Response to Referee

Thank for insightful and constructive comments from Anonymous Referee. We have reviewed the comments and provided our responses herein. We truly believe that the changes suggested by Referee will enhance the quality of the manuscript. A point-by-point response is presented below.

Fig 1. Comparison between the recorded and simulated values at the Huangpu Park tidal station.

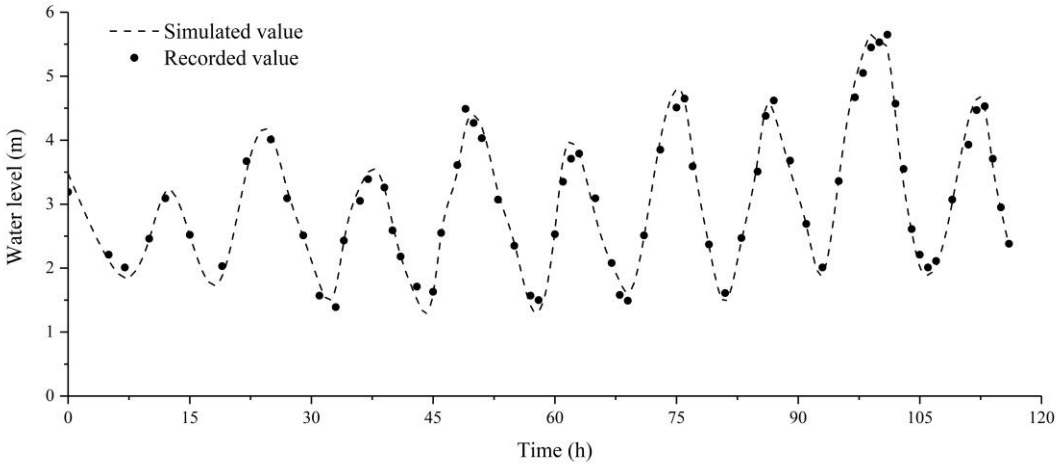
R2: In the section of Model validity, the author should illustrate the capability the LISFLOOD-FP flood inundation model. I suggest the author propose the validation plot between the observed and simulated value of storm surge and water level for tide stations used in this study.

A2: Thanks for your comments. Through discussions with the project team and incorporating your suggestions, the validation relationship between the simulated and observed values of storm surge and water levels at the tidal station was plotted using the observed records from the Huangpu Park tidal station for comparison (with reference to the observed data from Yin (Yin et al, 2013)), and the results show a reasonable match between the simulated data and recorded data (Fig 1). The effectiveness of the Lisflood-FP model in this study area we have explained in section 3.3. In addition, we compare the two-dimensional flood inundation extent with the flood disaster records and the literature records, and show that the inundation results are in better agreement with the actual situation.

Thank you again for your comments, and we have added the corresponding

explanations in the manuscript (Line 191-196).
